Wisconsin Department of Transportation

Proposal #12: 1228-16-71, WISC 2018 142
North South Freeway
Green Tree Rd Bridge B-40-0149
IH 043
Milwaukee County

This is Addendum No. 01, which provides for the following:

Addendum No. 01
 ID 1228-16-71
 Revised Sheet 441
 March 6, 2018

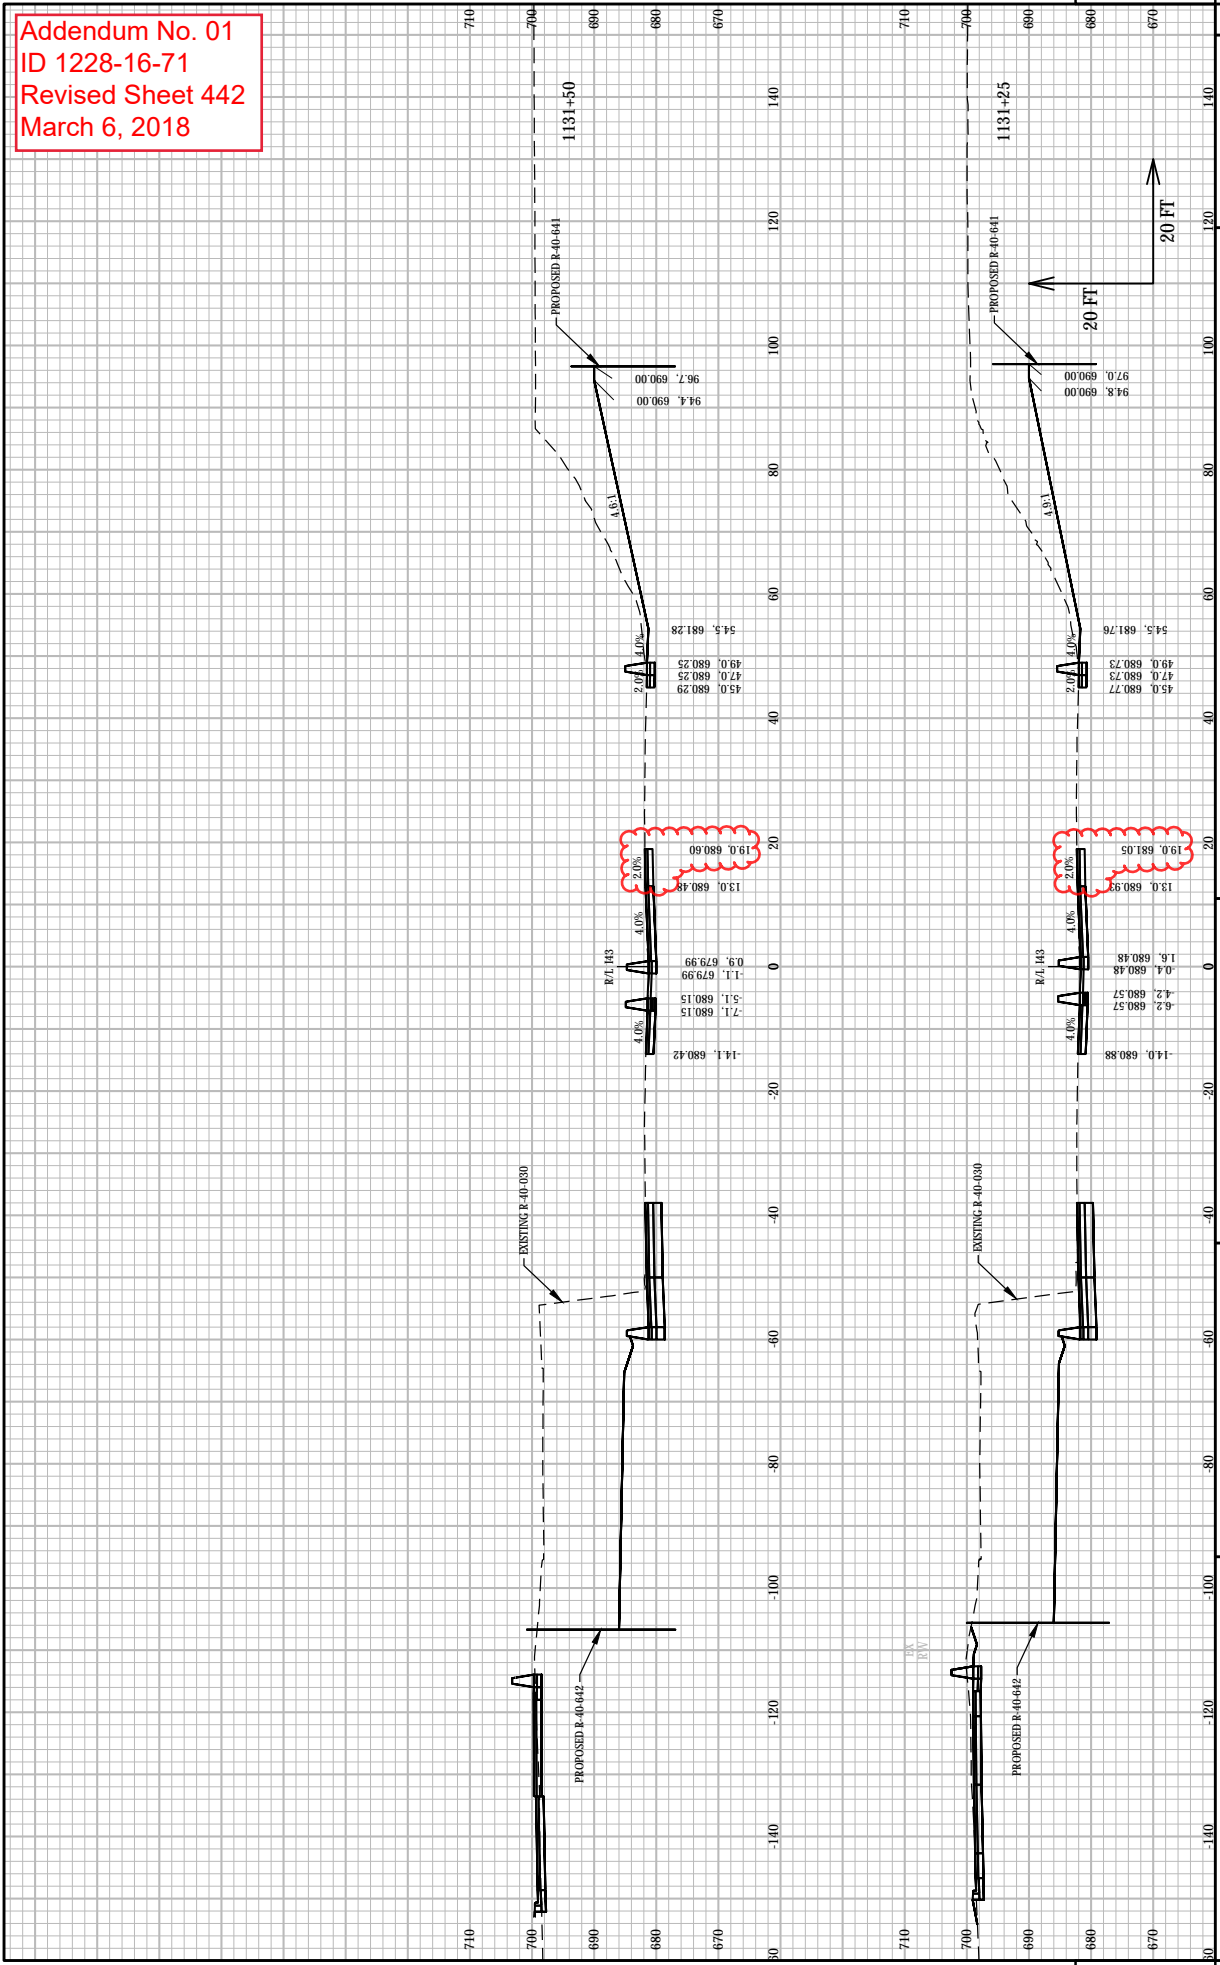
441	Cross Sections – IH43: Update to the I-43 NB median shoulder
442	Cross Sections – IH43: Update to the I-43 NB median shoulder
443	Cross Sections – IH43: Update to the I-43 NB median shoulder
